Brewery Road Apartments, Stillorgan, Co.
Dublin

Stormwater Audit Stage 1

Document Number: 192-206-SWA-S1

DETAILS OF PROPOSED NSBP003 KLARGESTER BYPASS PETROL INTERCEPTOR IN BASEMENT SLAB

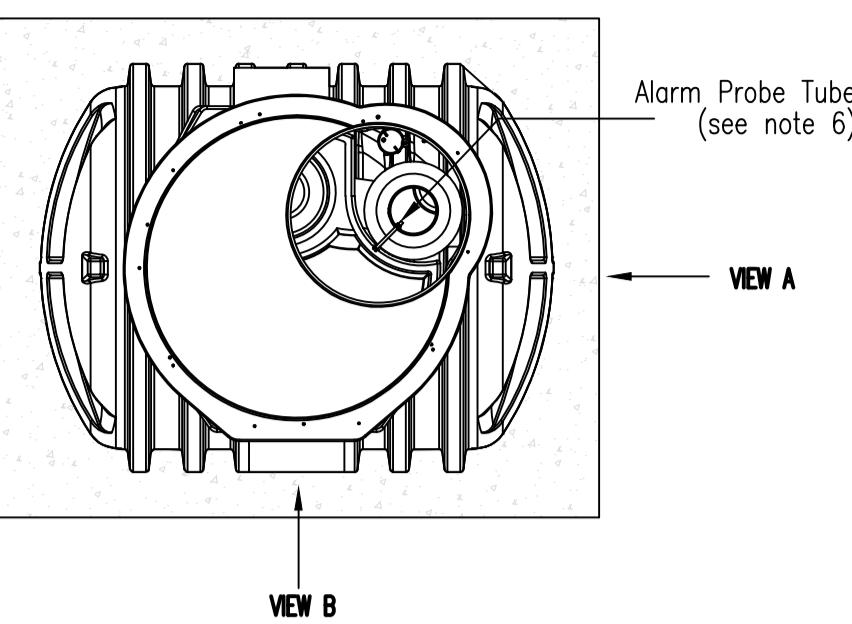
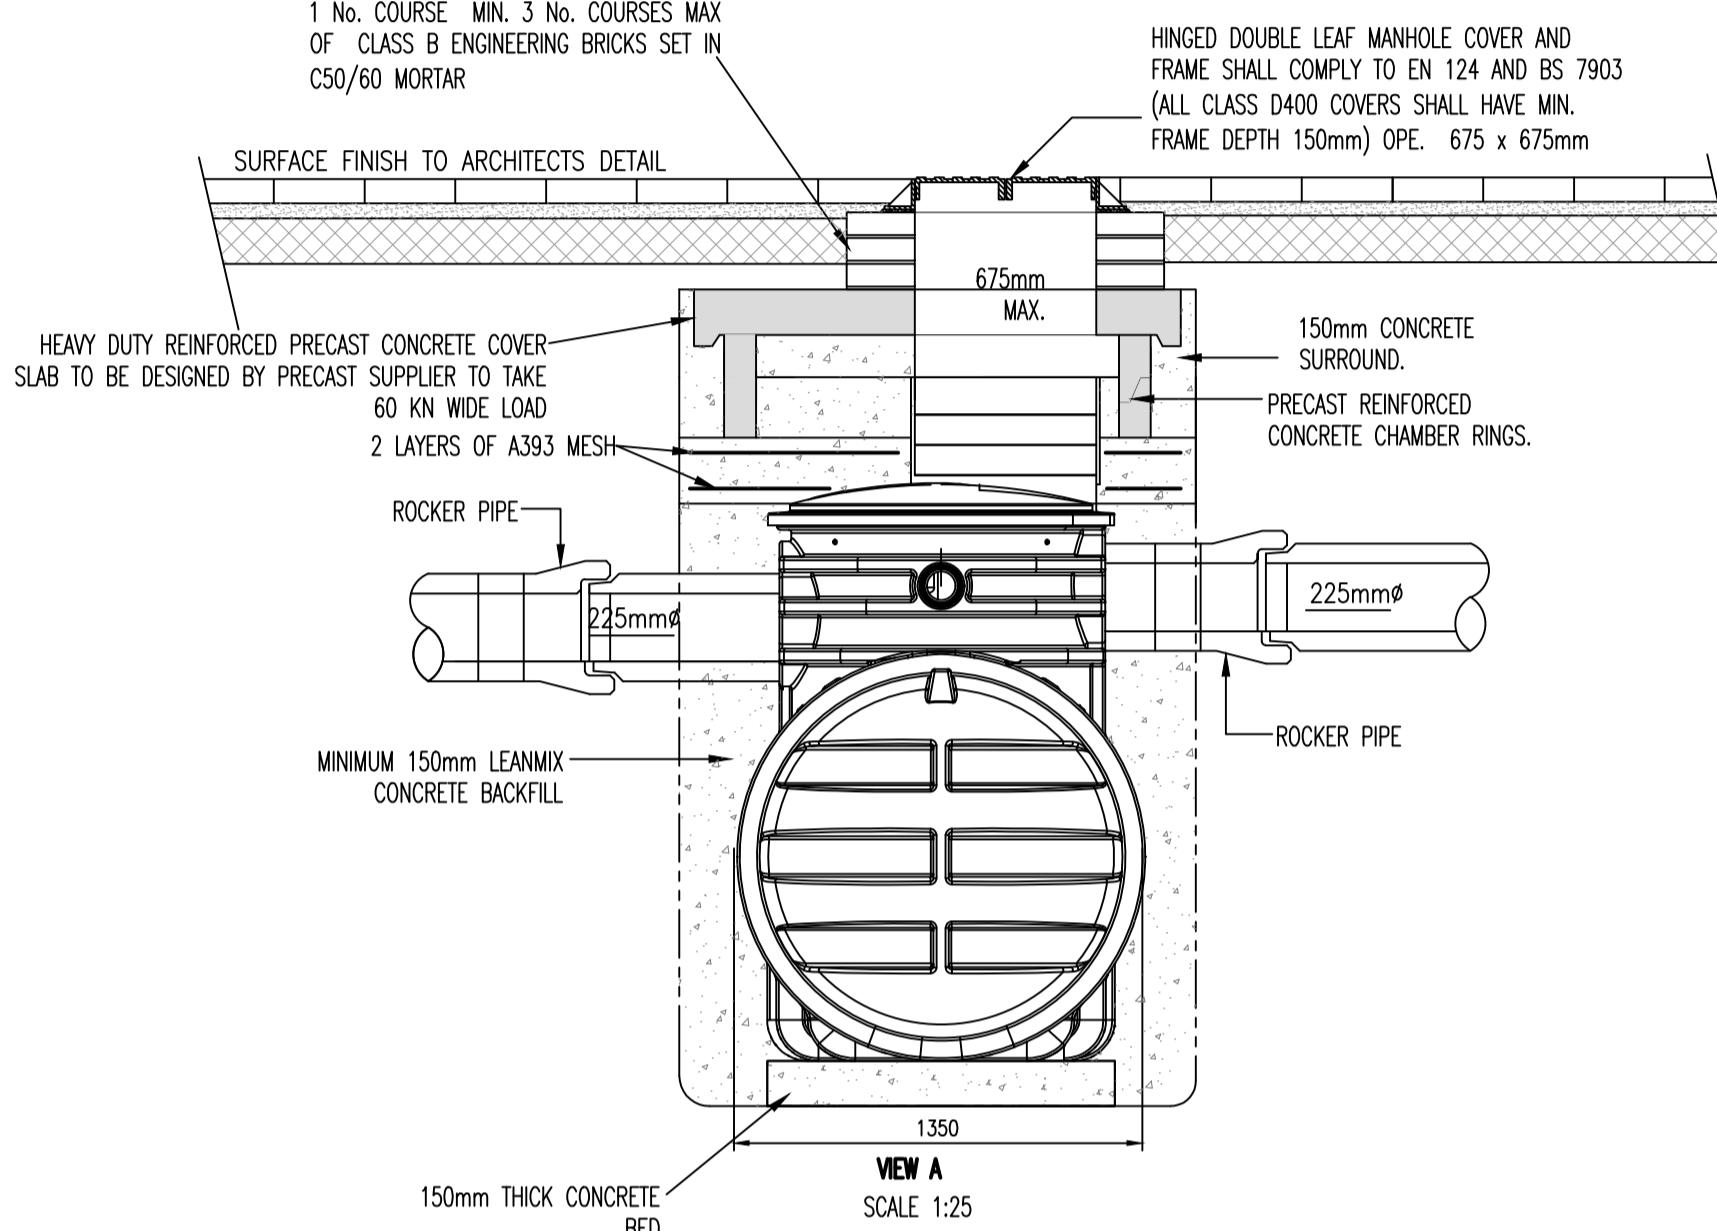
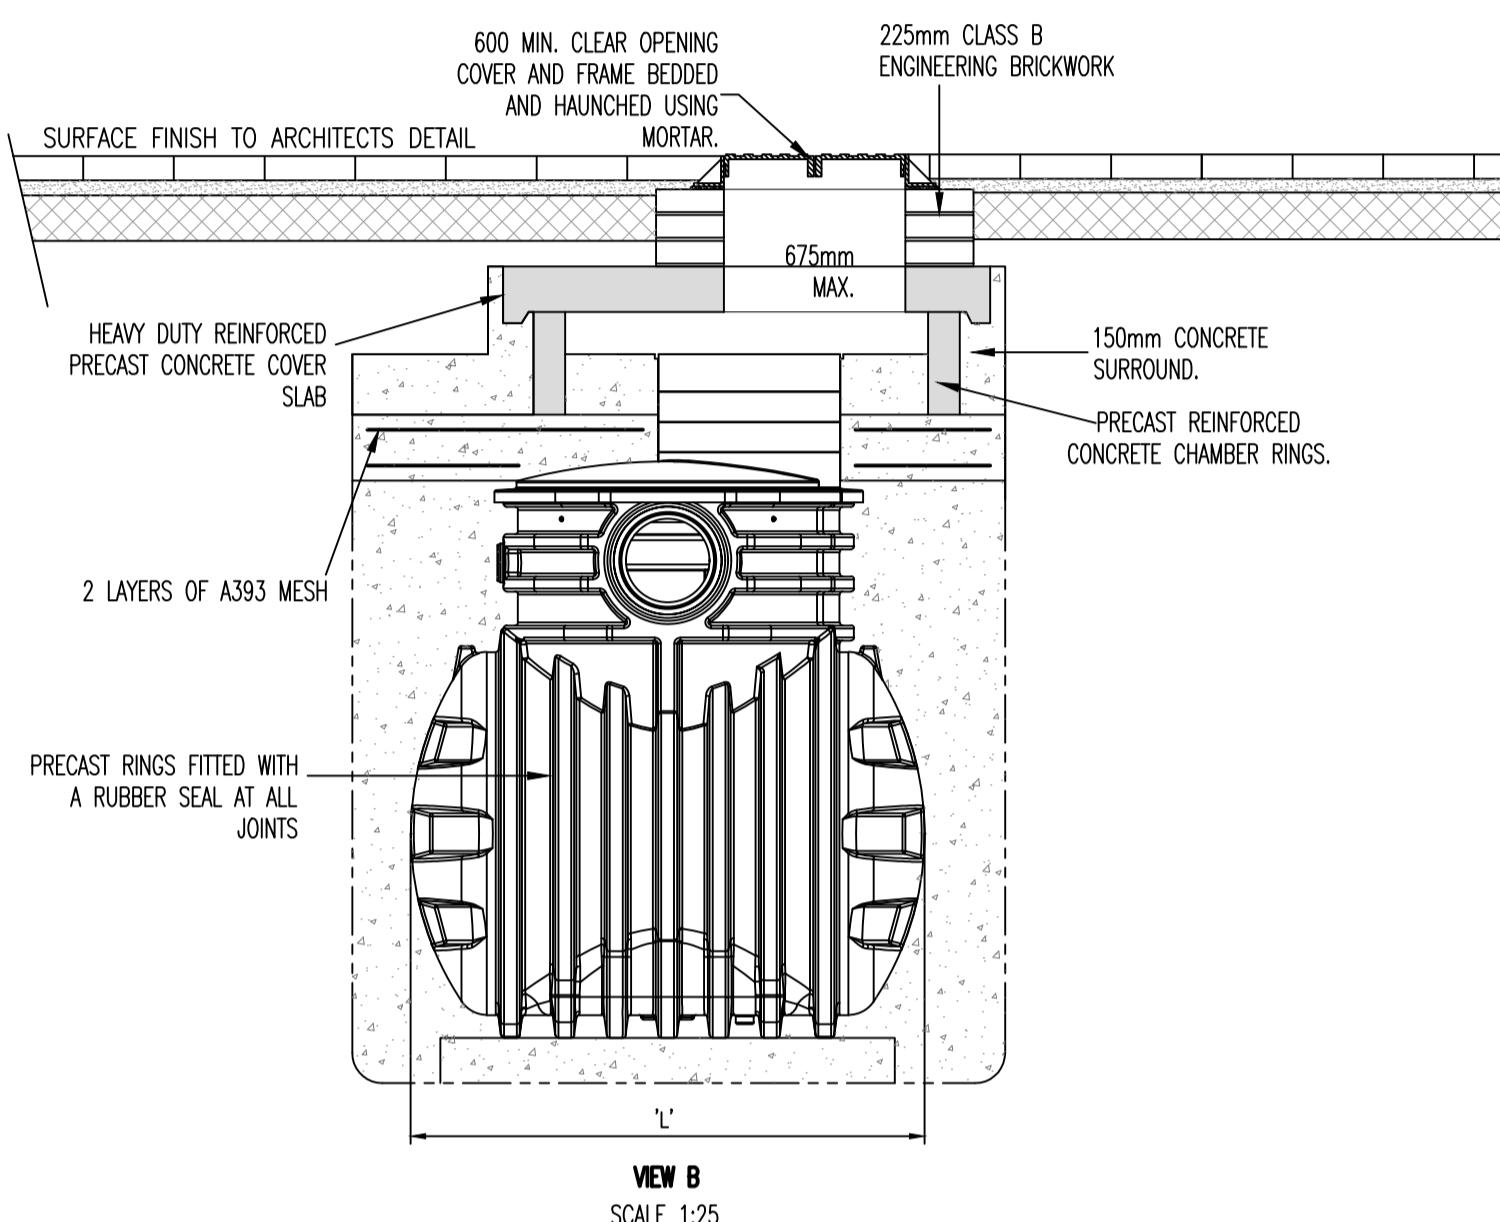
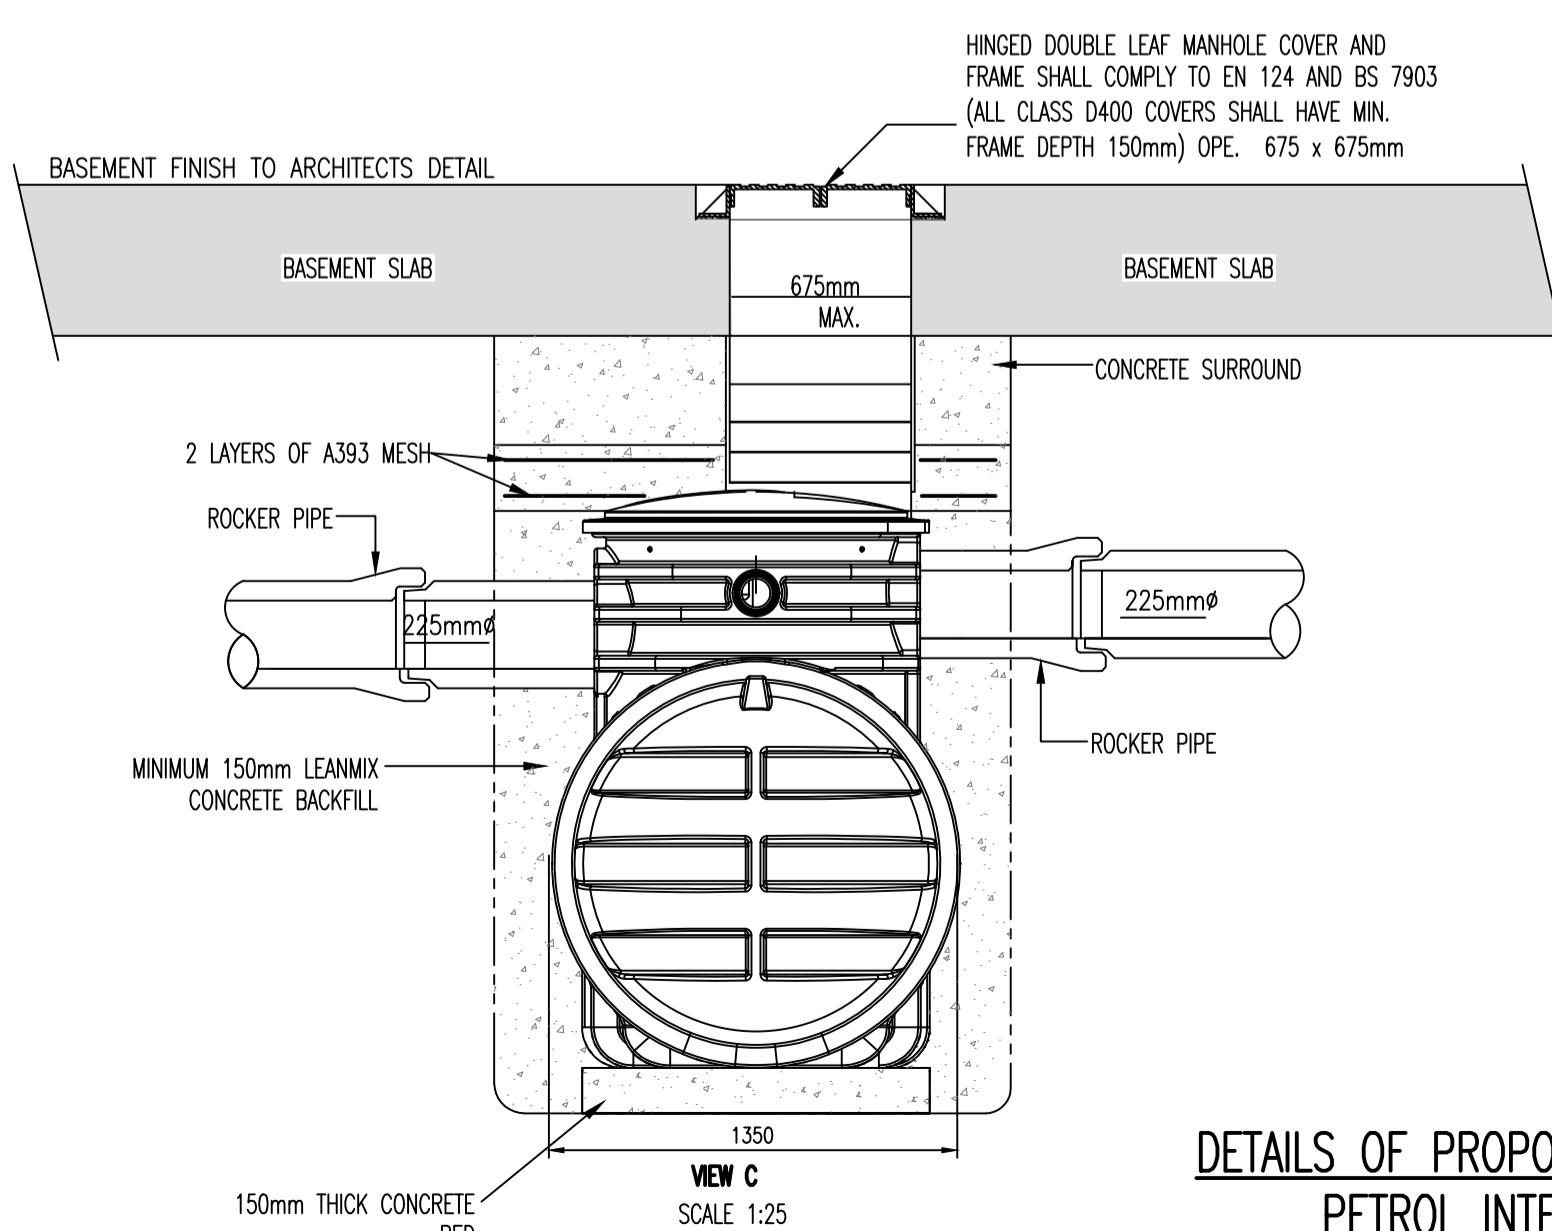
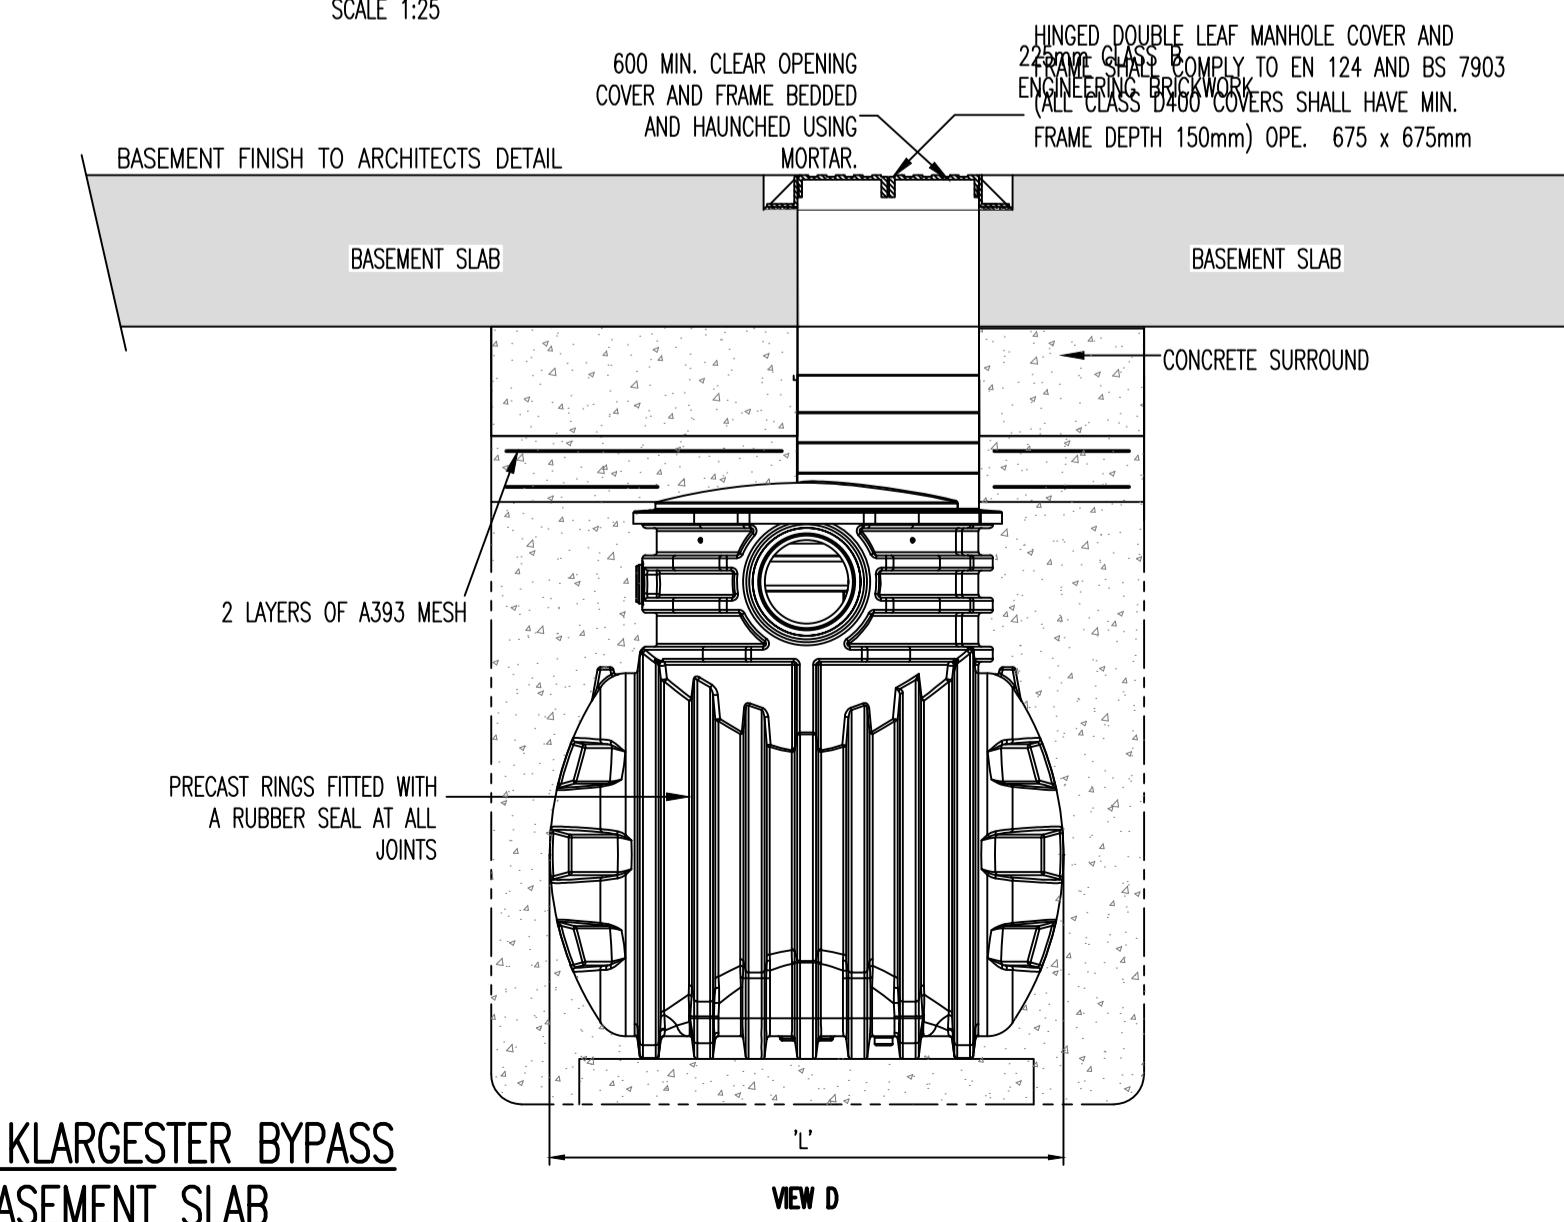
Problem: Bypass Interceptor details provided only refer to the basement interceptor.

Recommendation: Please confirm if the Petrol interceptor to the North of Block N is to be the same as the Interceptor being provided in the basement. If not, please provide details of the Petrol Interceptor to be provided at this location.

PROPOSED HYDROBRAKE MANHOLE SMH8

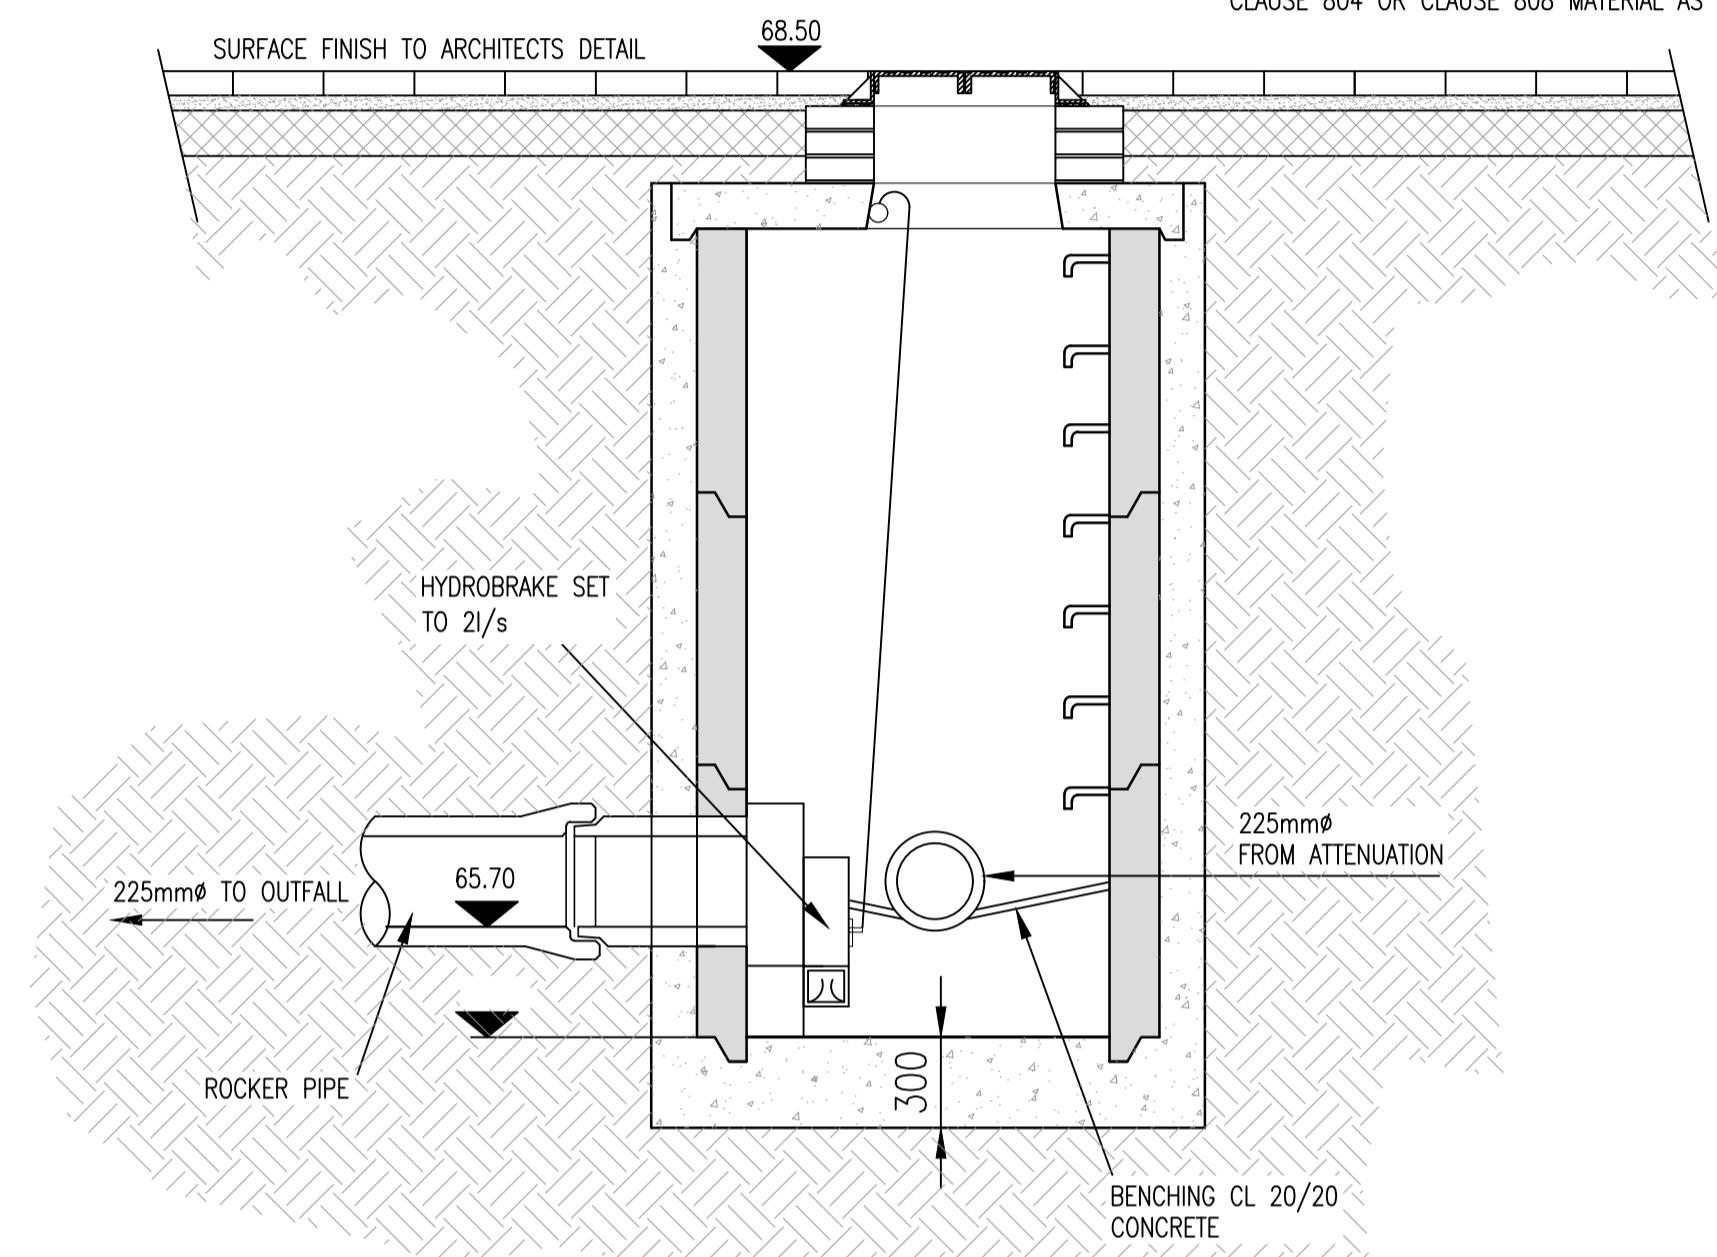
Problem: Hydrobrake details (orifice size, make and model) not submitted

Recommendation: It is also noted that the orifice size of the Hydro-Brake required is 53 mm, which is not considered practical for maintenance. We do not recommend use of a flow control device with an orifice below 75mm diameter. If a larger diameter is not achievable, please confirm what procedure will occur to prevent flooding in the case of a blockage. Consider installing a sediment reduction/removal device (such as a Downstream Defender or equivalent) upstream of the Hydro-Brake.

Problem: Hydrobrake details submitted differ between drawings and Engineering Report. Engineering Report states total discharge of 5.65 l/s, drawings call off both flow controls as 2 l/s each.

Recommendation: Please Clarify the discharge of the 2 no. hydrobrake being provided.

2.1.11	Y	Y	Please see revised Hydrobreak details, drawings and calculations attached. Hydro-International have confirmed that it is not possible to achieve a 75mm orifice with such a low flow rate therefore a mesh guard, which is installed on the hydrobreak to help prevent blockages, will be specified as standard practice. In addition, Silt trap manholes will be provided prior to the final discharge of the network into the attenuation tank which will reduce the volume of debris entering the tank.	Yes
